COMMUNICATION from the City Plan and Zoning Commission advising that at a public hearing held July 16, 2009, the members voted 12-0 in support of a motion to **APPROVE** the request from Baker Real Estate, LP (owner) represented by Bernice Baker (partner) for review and approval of an amendment to the "Cold Stream Business Park", a Preliminary Subdivision Plat of property located at 4500 Hubbell Avenue, for creation of nine (9) lots on 49.67 acres of land with extension of a public street from Hubbell Avenue. The proposed amendment changes lot size configuration and location of public street extension subject to the applicant revising the Plat as follows:

Cold Stream Business Park - Preliminary Plat - NE 46th St & Hubbell Ave 13-2009-1.30

Preliminary Plat, Coldstream Business Park (Revised

13-09-1.39

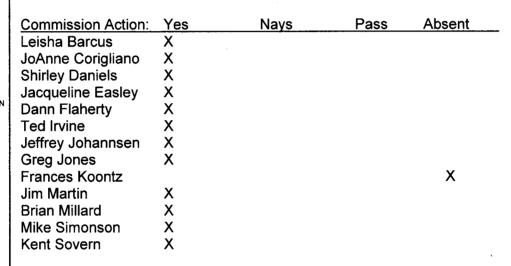
- 1. Some of the proposed elevation contours shown in Lot 4 and Lot 5 look unusual. There appears to be a 95 tied into a 105 near the west end of the FUTURE ROAD on the Lot 4 and 5 shared lot line. The existing 100 in the NE corner of Lot 5 does not tie into a proposed 100.
- 2. Some more work needs to be done to show proposed elevation contours into existing elevation contours in the northern portion of Lot 7.
- 3. Make sure that the proposed rough-graded building pad area in Lot 5 is high enough to gravity flow to the sanitary sewer main with a service, all within Lot 5.
- 4. Apply for a Grading Permit and pay the fee in conformance with Code. Provide the design basis for the rip rap erosion control areas shown.

- 9. Show the assigned street name of E. 44th Court for the proposed public street into the development.
- 10. There is overlapping text that should be corrected in the lower left quadrant of sheet 1. Also, there is overlapping text on sheet 2 near the symbol legend.

- 11. How will the newly configured plat area affect tree removal for this project? A separate tree inventory survey indicating trees over 6" caliper to be removed within the plat boundaries will need to be submitted.

- 12. The note on sheet 1 pertaining to a P & Z approval date will need to be amended to reflect the date of P & Z approval of the latest plat configuration.

- 13. Provide tree protection notes on the preliminary plat. A copy has been enclosed for your use.
- 14. The previous approval of the plat came with the following condition, which should be reflected on the plat (unless it is waived with the approval of the resubmitted and amended plat):

- "A tree mitigation measure note should be shown requiring 5 additional 2" caliper overstory tree plantings per lot in addition to any minimum plantings as required as part of the site plan development."

- 15. Show lot addresses on the plat:

16. Remove the "pond" lettering on the north central portion of Lot 6. This appears to have been a location of a previous detention facility that has sense been removed.

- 17. Note on the plat that stormwater management will be provided to conform to the City's Site Plan Ordinance policies and standards in Section 106-136.
- 18. There appears to be plenty of proposed grading work shown near the "future road" extending into lots 4 & 5 and the proposed rip rap outlet areas on either side of the drainage culvert. Revise the conservation easement boundary areas to remain outside of where grading will occur on this portion of the development.
- 19. The PUD Concept Plan will need to be finalized with the Planning Division prior to issuance of the Grading Permit.
